## Combined Victorian Society Testimony for May 2, 2023

## LPC-23-08020 -- 120 Broadway - Equitable Building - Individual Landmark, Manhattan

## LPC-23-07180 – 1260 Broadway - Hotel Martinique - Individual Landmark - Manhattan

# LPC-23-09159 – 200 Convent Avenue - City College, City University of New York (CUNY), North Campus - Individual Landmark, Manhattan

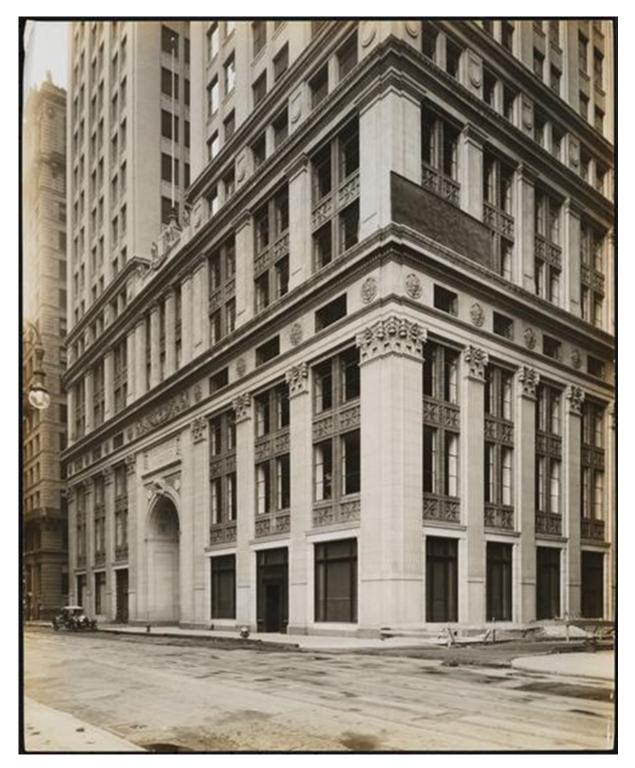
We found the presentation material for this application so lacking in clarity that it was difficult to prepare testimony. The existing and proposed elevations of the storefront bay in question are too small and lacking in detail, making it difficult to understand the proposed design. There is no detailed view that would show us what the historic storefronts were like, to help guide the new design, so we have provided below photographs from 1915 and 1930. As would be expected, the ground floor once had a design commensurate with the rest of the building.

We know that the Commission can't require restoration of historic features missing at the time of designation. Nonetheless, we don't understand how such a pedestrian storefront design, using anodized aluminum, can be an appropriate standard for a building of this consequence.
